MEMORANDUM FOR BIOMEDICAL MAINTENANCE

SUBJECT: Physio-Control Battery Support Systems

Attachment:  
Battery Support System Screw Replacement Instructions

**Figure 5-1 Battery Support System Final Assembly**  
Part Number 801807  
(Sheet 1 of 2)

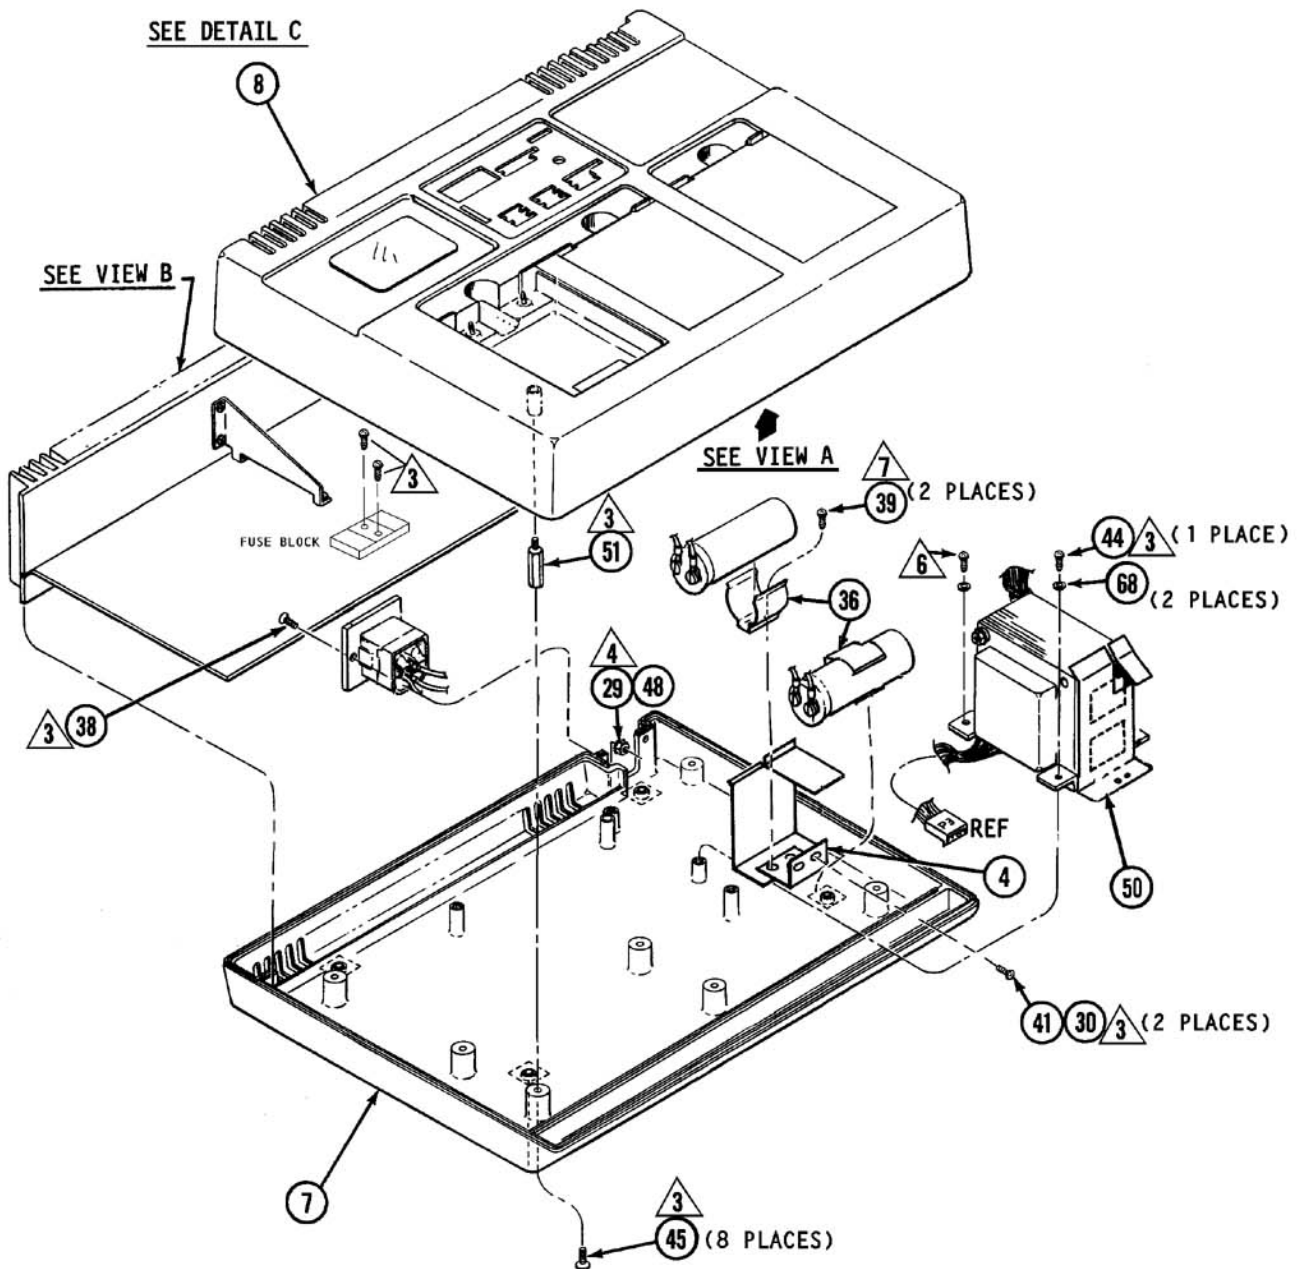
**1** REPLACE SCREWS WITH 202253-068  
6-32 x 0.25L NYLOK (14 PLACES)  
\*NOTE: If screws in terminal  
block are 5-40 thread, use  
alternate 5-40 screws  
provided.

**2** REMOVE AND DISCARD FLAT WASHER  
(1 PLACE)

**3** APPLY THREAD LOCKER TO THREADS  
222MS (LOCTITE) (41 PLACES)

**4** REMOVE RTV (2 PLACES)  
If the RTV is not holding the nut  
securely, then it should be removed.  
If the RTV has not degraded and  
continues to hold the nut securely to  
the case, there is no need to remove it.

**5** TORQUE 10 to 12 IN. LBS.  
(3 PLACES)

**6** REPLACE SCREW WITH 202253-570  
6-32 x 0.375L NYLOK (1 PLACE)

**7** TIGHTEN TO SNUG (2 PLACES)
